November 7, 2019

**Re: Northern Pulp Nova Scotia - Environmental Assessment Registration Document-
Replacement Effluent Treatment Facility (Focus Report)**

Figure 3-12: Atlantic Mackerel and Atlantic Herring distribution and harvest areas

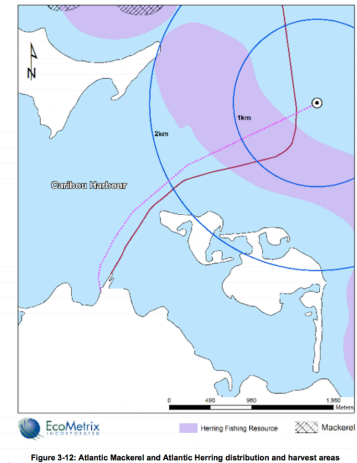
Appendix 7.3 of the focus report contains the statement "*the proposed pipeline route will directly interact with the known Atlantic Herring resource*" (**Figure 3-12**) This is not Science. Our herring stocks are in trouble and fishermen have taken drastic quota cuts and shorter season openings in order to protect this vital specie, and a pipe line and a outfall of toxic effluent isn't a pro-active approach to protect this fish resource. For these reasons, no risk should be taken to this vital industry and vital ecosystem of the Northumberland Strait, and the project should be rejected.

Scallop Buffer Zone

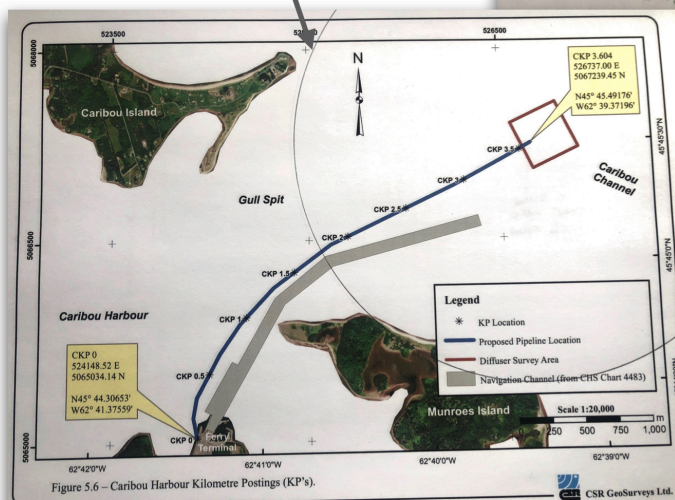
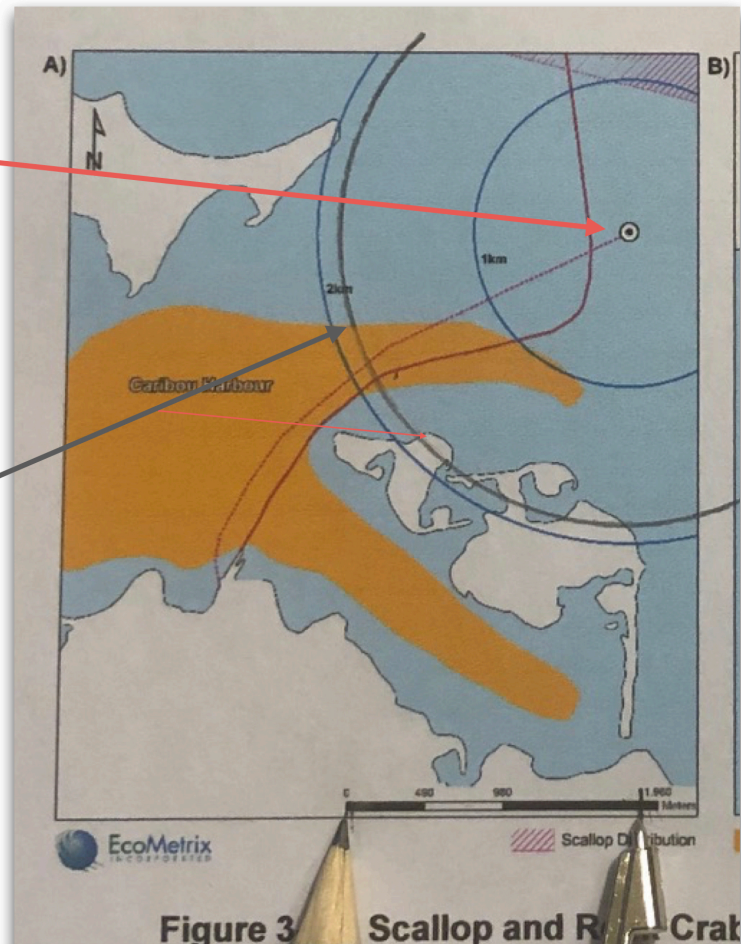
With this pointed out I would then like to refer to Northern Pulp's focus report - section 7.3 Marine Environment Impact Assessment (**figures 3-11, 3-12, 3-13, and 3-14**) and then the wording on page 3.35 where they state the outfall location is outside of this buffer zone, but the pipe route is within the refuge. It is true the pipe route is within the refuge, but also the outfall location is within the refuge as well, as 1 nautical mile equals 1.852kms. If Northern Pulp worked with DFO more, they would have been shown and told that their figure in their focus report was incorrect and that the scallop buffer zone is one nautical mile from any point of land. This means their outfall is located inside a marine refuge area which is intended to protect the juvenile American lobster <http://www.dfo-mpo.gc.ca/oceans/oeabcm-amcepz/refuges/sfa-zpp-eng.html>.

Another concern is that within this refuge to protect fish habitat, they will be digging a trench 3.6km long to lay the 36 inch pipe. To dig this trench as stated in Appendix 2.5, page 18, they will be moving 20,000 cubic meters of fill per km of pipe line. So for a 3.6 km pipe line, that's approximately 72,000+ cubic meters of material being dug within a marine refuge area. Now to put that into perspective a dump truck travelling down the highway carries on average 7.6 -10 cubic meters per load. If we were to pick 9 cubic meters as an average, that would be like filling 8000 dump trucks of material out of a marine refuge area that is designated to protect fish and fish habitat. So as I have stated before, for the reasons above I ask you to reject this project submitted by Northern Pulp.

outfall is within
1 nautical mile of
scallop buffer zone

pencil lined circle area
represents one nautical
mile around outfall
coordinates

Chart of Caribou Channel and surrounding area

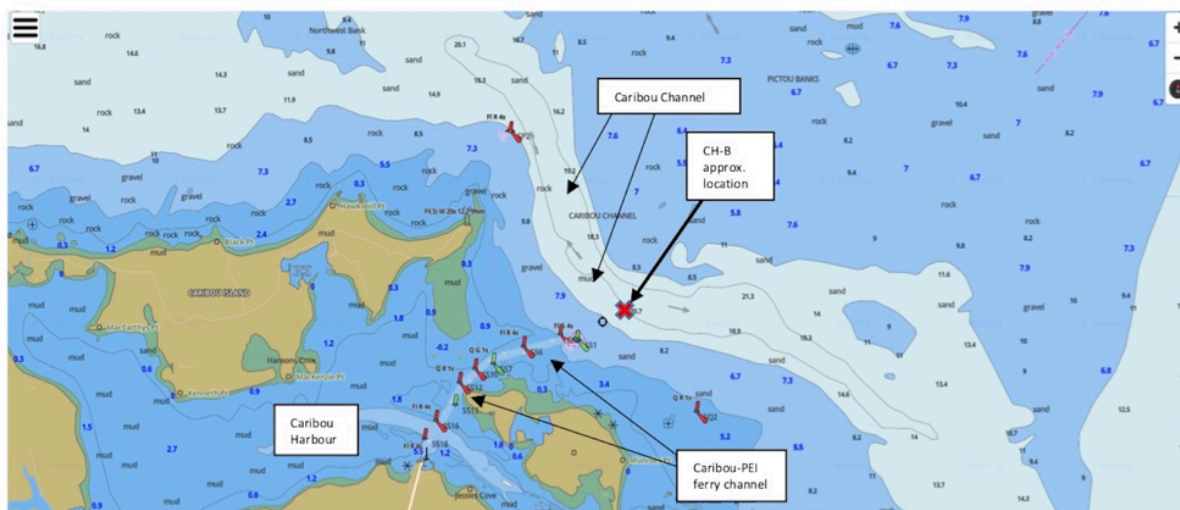
The accumulative affect and build up is unknown and needs to be addressed. The area in which the outfall is located, is stated in Appendix 2.2 to be 20m in depth, but around the outfall location the depth decreases to 18m within 100m from the outfall and continues to rise as you go outwards from the outfall. What will the accumulation in this area be and what will happen to the diffusers in this situation as they get taken over by accumulation of suspended solids. At slack tides every 6 hr, the suspended solids won't just go away!! So, because the cumulative effects of 4 tonnes per day of TSS are unknown I ask you to reject this project.

Northern Pulp's proposed outfall at point CH-B in the Caribou Channel is to be placed in a relatively small area with a depth of 20 metres. As this chart illustrates, the area becomes significantly shallower within a short distance. Depths are more typically between <1 to <8 metres in most of the surrounding Caribou Harbour and Pictou Banks area.

Comparison Of Outfall Depths & Tides

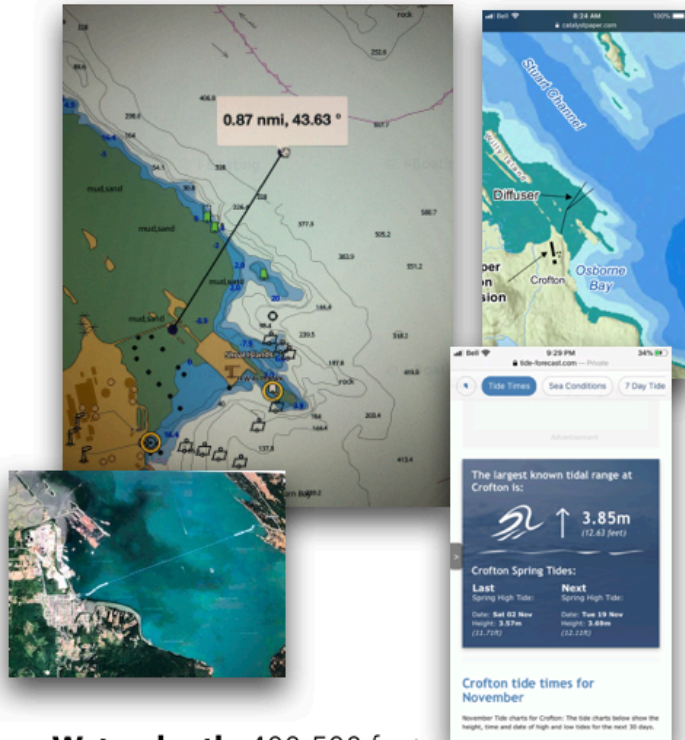
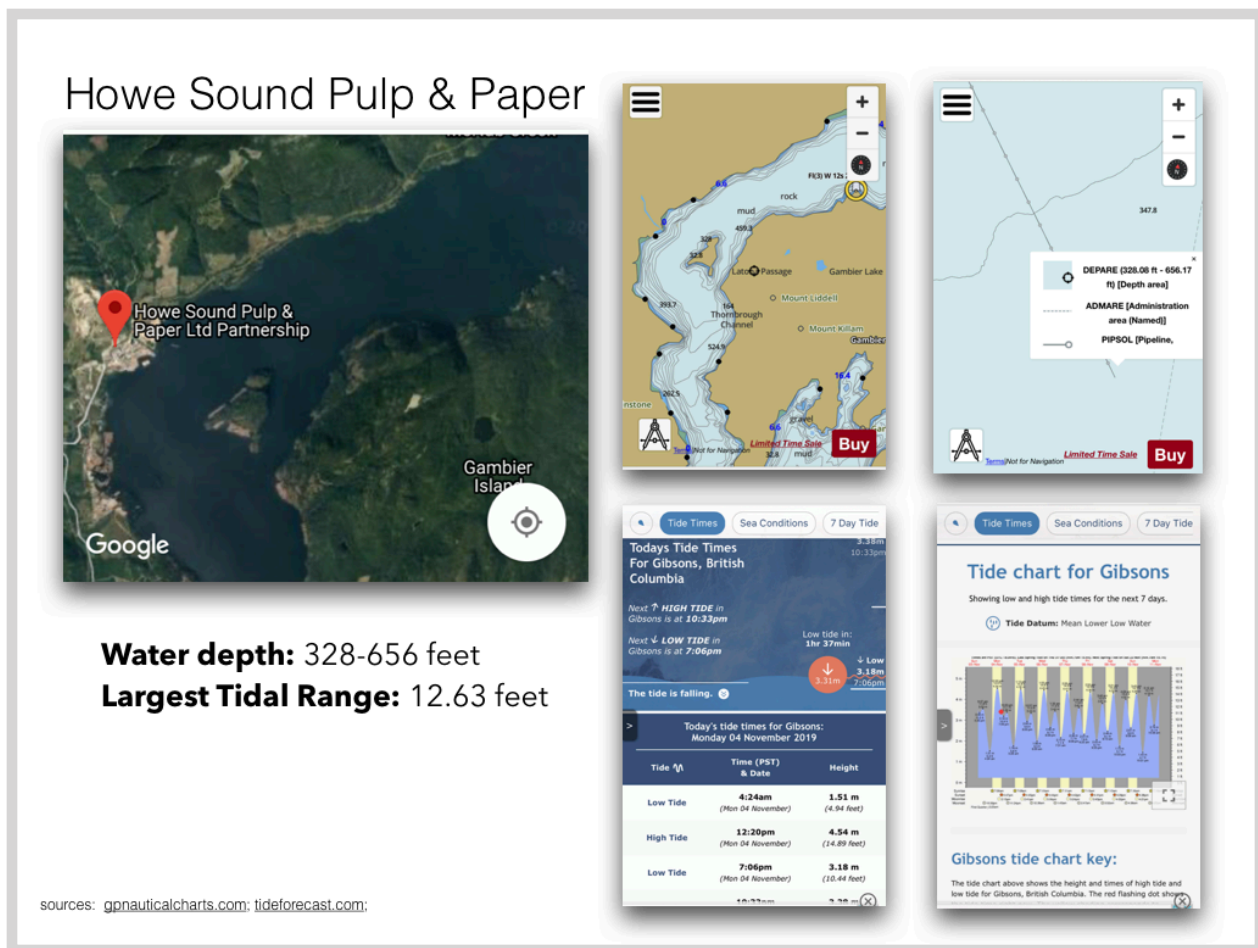
Northumberland Strait's tidal range is classified as Micro-tidal, when the **tidal** range is lower than 2 metres. (https://en.wikipedia.org/wiki/Tidal_range). Northern Pulp has not proven that such a low tidal range could effectively disperse 4 tonnes of TSS daily.

Water depth: 400-500 feet
Distance from Shore: 1.96 nautical miles
Largest Tidal Range: 12.63 feet

Water depth: 67 feet
Distance from Shore: 1.84 nautical miles
Largest Tidal Range: 6.1 feet

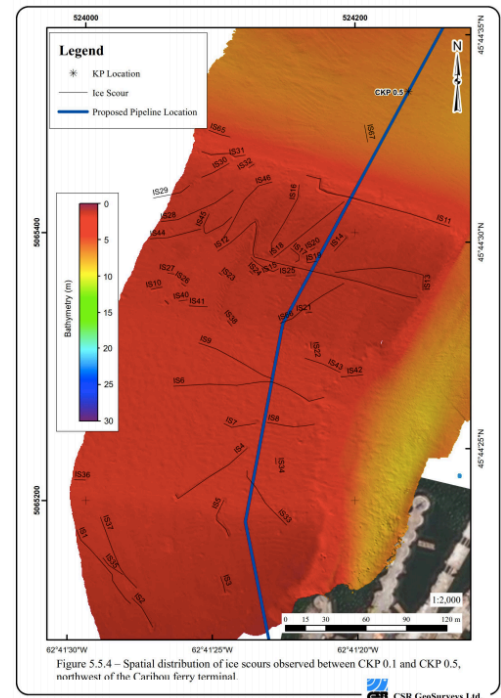
With these scours and the water depth of only 0.22m to 19.06m (appendix 2.2 page119), what is the interference with the Navigation Protection Act?

As stated within the act **Prohibition 3**, *it is prohibited to construct, place, alter, repair, rebuild, remove or decommission a work in, on, over, under, through or across any navigable water that is listed in the schedule except in accordance with this Act or any other federal Act.*

In appendix 2.5, they indicate that there plan is to dig a trench to the depth of 3m and install a 1m pipe with 2m of top soil on top. Then for sea ice scours protection in areas of concern which have yet to be decided on will be protected by armour rock which will decrease harbour depth by increasing the coverage over the pipe. How will this pipe line route, with very little depths to begin with, have enough water to avoid impeding on the Navigation Act for water travel by canoes, fishing vessels, ferry etc? How can this pipe line route be granted with the Navigation protection Act in place for the safe passage of travellers?

Ice Chart of Gulf of St Lawrence and Northumberland Strait: 03/09/19

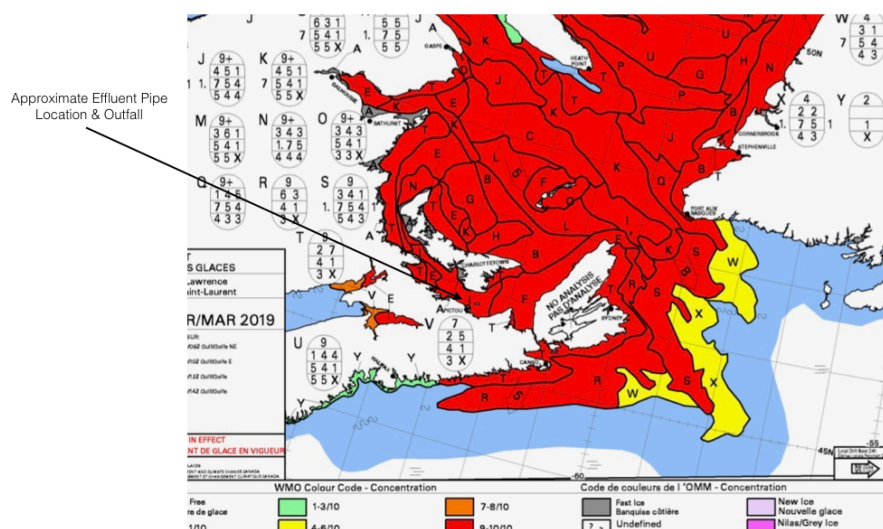
As stated in the focus report, the exact route has yet to be designed and mapped, so how can a proposal be approved without knowing if no navigation will be interrupted? The depth just isn't there. So for this reason the project submitted by Northern pulp must be rejected.
